MIL-C-71042 (AR)
AMENDMENT 2
27 March 1998
SUPERSEDING
AMENDMENT 1
26 August 1994

MILITARY SPECIFICATION

CIRCUIT CARD ASSEMBLY, LOGIC: 11784523

Figure 1. Voltage Outputs per Paragraph 3.6.8.3

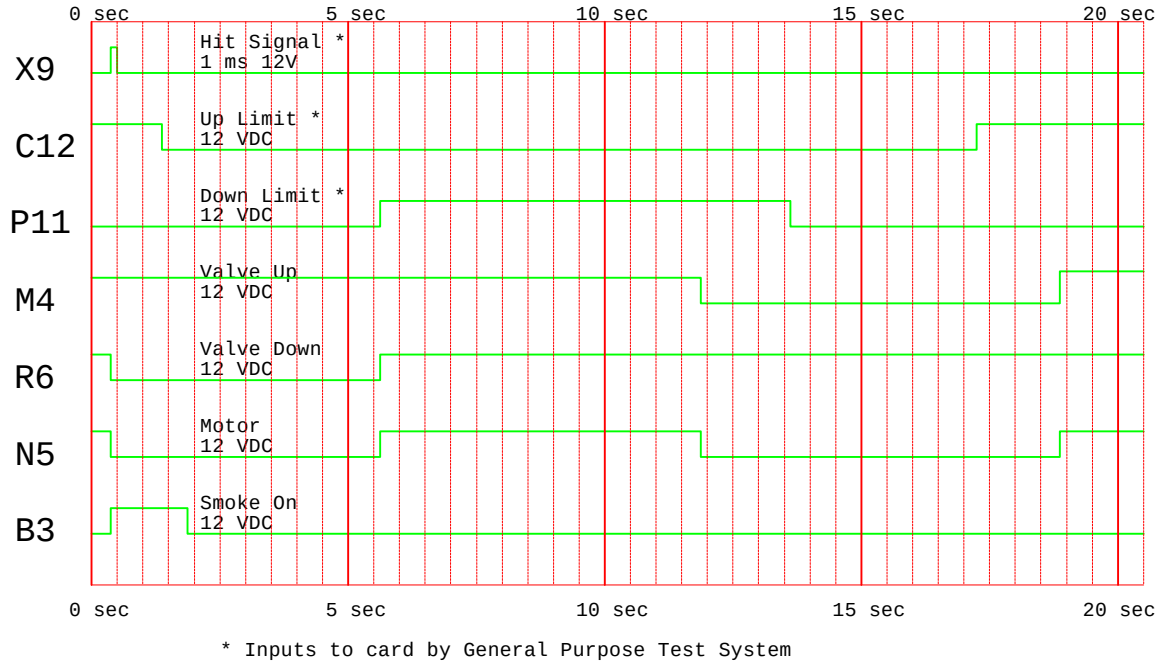
* Delete: “Figure 1” and substitute new “Figure 1” (see page 4)
